T10/05-079r2 SAS-1.1 Minimum XR/IR Receiver Signal Level for 3Gb SATA Mode

To: T10 Technical Committee
From: Barry Olawsky, HP (barry.olawsky@hp.com)
Date: 7 March 2005
Subject: T10/04-079r2 SAS-1.1 Minimum XR/IR Receiver Signal Level for 3Gb SATA Mode

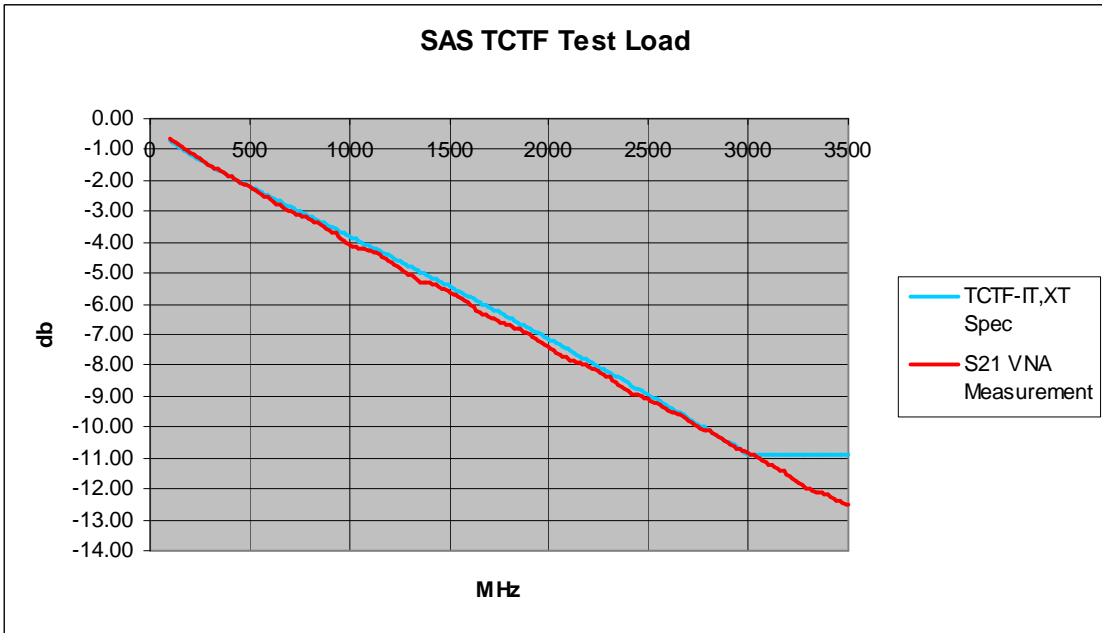
Add a subsection to "media specifications" defining the insertion loss characteristics of the low loss TCTF. The subsection shall include an insertion loss equation and graph that applies to 3Gb SATA gen2i transmitter devices ONLY. The below equation is obtained by scaling the 3Gb TCTF-IT equation such that 6dB insertion loss is obtained at 4.5GHz. The proposed graph is:
